MEMORANDUM

DATE January 3, 2022 PROJECT 16252A.77
NUMBER
TO Danielle Condit, Associate Planner PROJECT 526 Waverley Street, Palo Alto
Danielle.Condit@CityofPaloAlto.org
OF City of Palo Alto Planning & FROM Hannah Simonson,
Community Environment Dept. Cultural Resources Planner
250 Hamilton Avenue, 5th Fl Christina Dikas, Associate Principal,
Palo Alto, CA 94301 Project Manager
Ruth Todd, Principal-in-Charge
CC Amy French, VIA Email
Amy.French@cityofpaloalto.org
REGARDING 526 Waverley Street, Palo Alto – *Secretary of the Interior's Standards for Rehabilitation*
Compliance Analysis

Figure 12. Rendering of proposed rear alterations. Source: Standard Architecture & Design, "Blu Dot Palo Alto, 526 Waverley Street, Palo Alto, CA 94301" (November 2, 2021), Sheet A000.

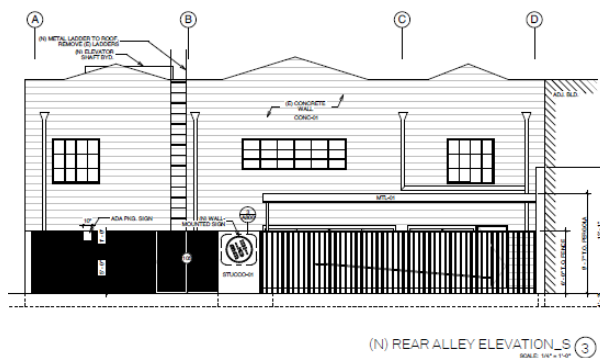
Appendix of this memorandum). The proposed project includes the following alterations (**Figure 12 - Figure 16**):

- A one-story metal frame shade structure with a wood slate roof will cover most of the patio
 - A 12:1 ramp will provide access from the fence gate to the shaded patio area

- A second paired gate will lead to a landing with several steps down to the shaded patio area
 - Rectangular concrete planters, planted with *pittosporum tenuifolium*, will be located at the north and west perimeters of the patio

Figure 15. Existing (bottom) and proposed (top) floor plan diagrams.
Source: Standard, "Blu Dot Palo Alto" (November 2, 2021), Sheet A005.

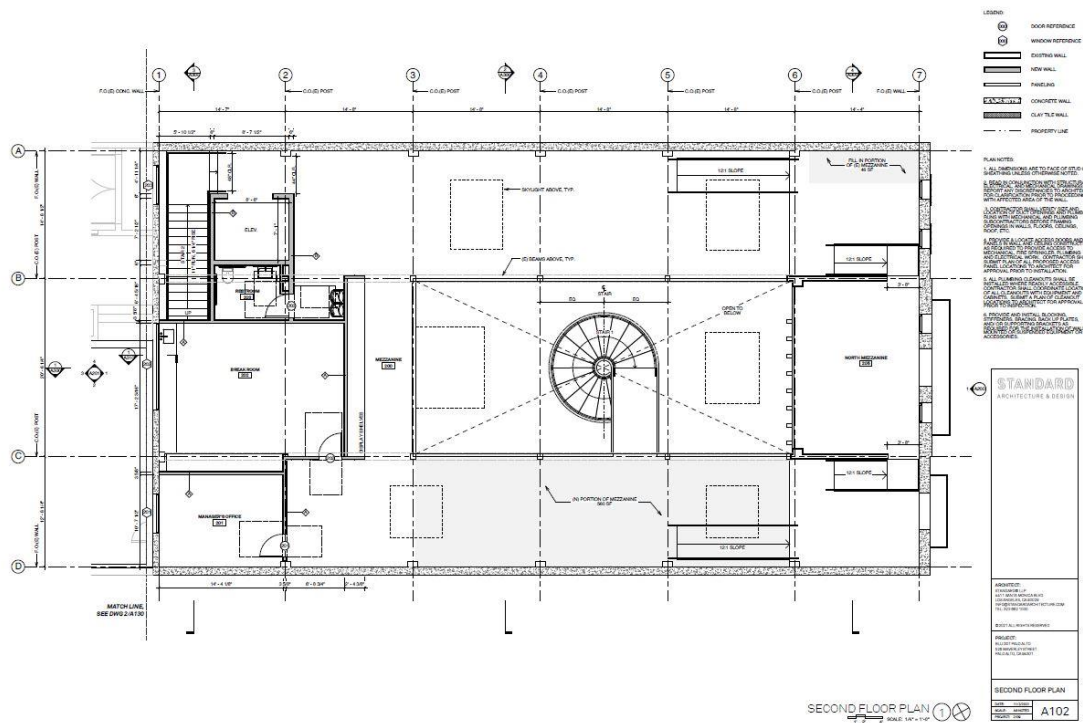
- Replacement of an existing central interior elevator with a new elevator and stair at the southwest interior corner
- Removal of stair at the southeast interior corner
- Installation of a new interior stair, which will be a central spiral stair
- Modifications to the interior mezzanine and partitions
 - Mezzanine will be expanded with an addition along the southeast wall, which will require the removal of a portion of the modified historic mezzanine railing. A new railing or low wall will be installed at the step between the mezzanine level change.⁶
 - Removal of section of front partition walls to provide doorway access between the three spaces along the front mezzanine
 - Ramps will provide access between the mezzanine level changes

- New partition walls to create an office, break room, and restroom at the rear end of the mezzanine
- Various interior mechanical, plumbing, and electric upgrades
- New ADA-compliant restroom.

Figure 16. Proposed second (mezzanine) floor plan.
Source: Standard, "Blu Dot Palo Alto" (November 2, 2021), Sheet A102.

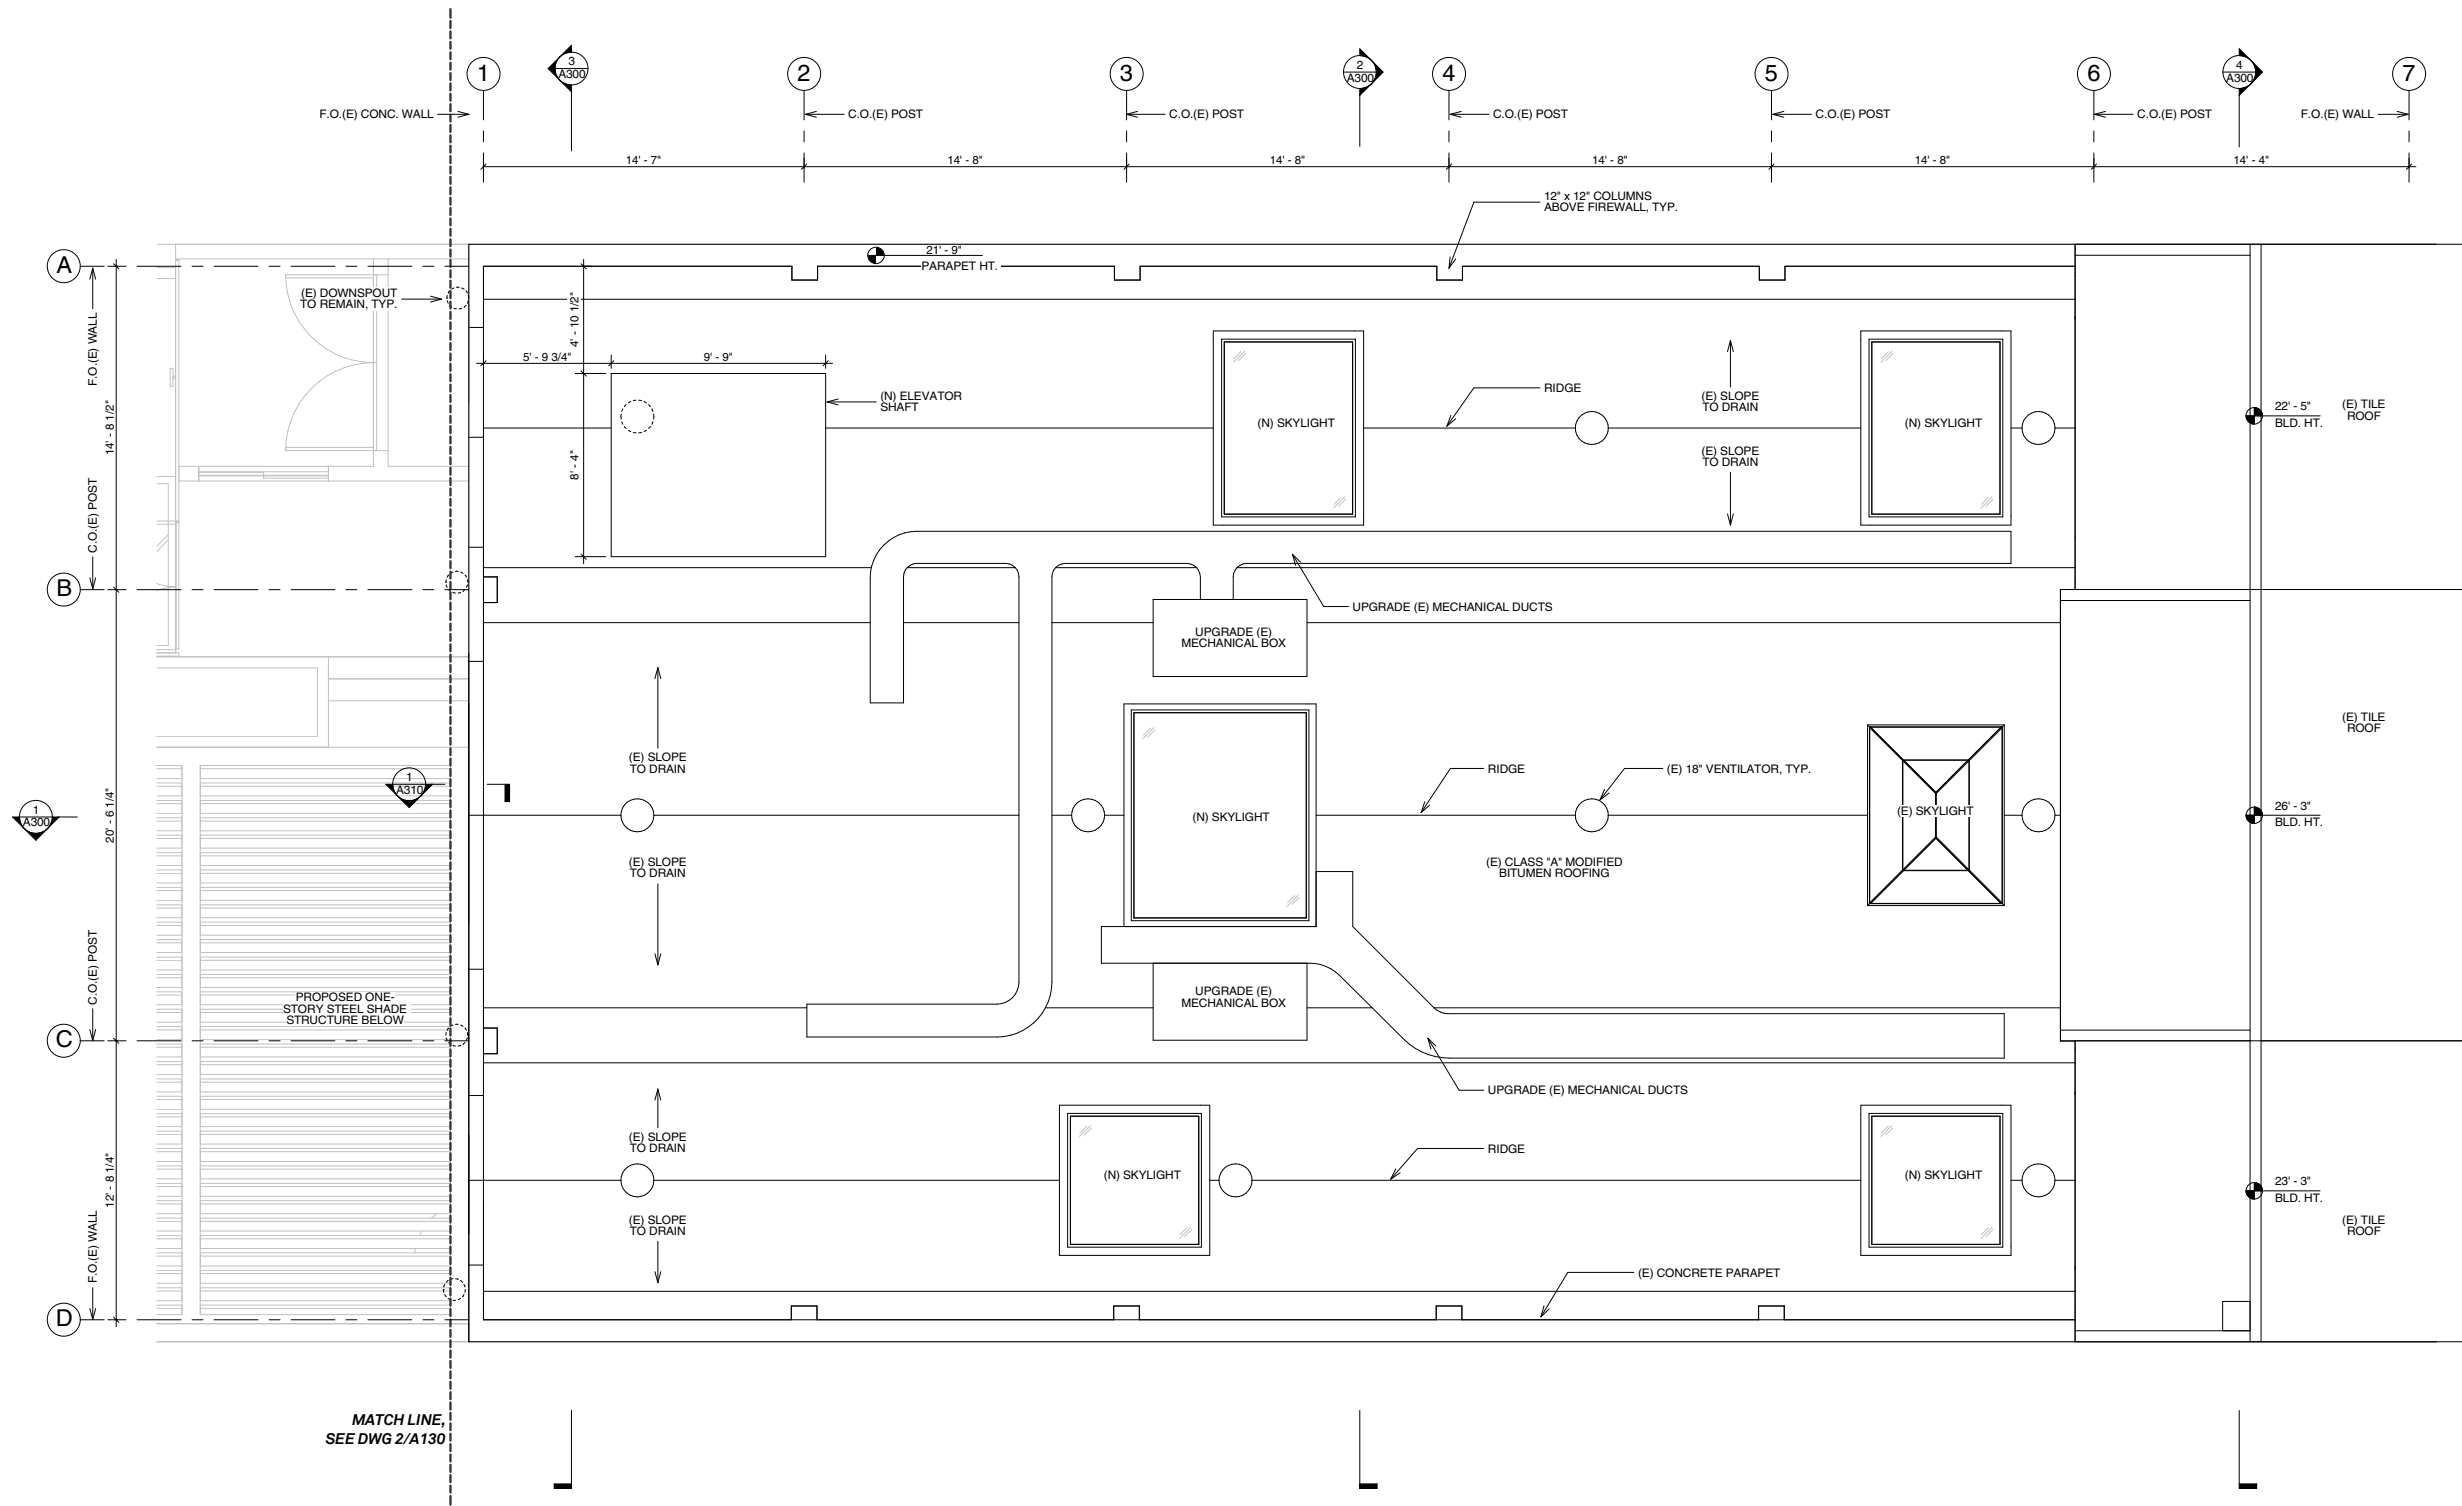
- **Recommendation #1:** Retain portion of wood railing at the east end of the mezzanine, adjacent to where a new ramp is being installed along the interior of the southeast wall. As the floor levels change between the existing front mezzanine and the proposed new mezzanine section, a railing or low wall of some kind will be required. Page & Turnbull recommends retaining as much of the existing wood railing to preform this function.
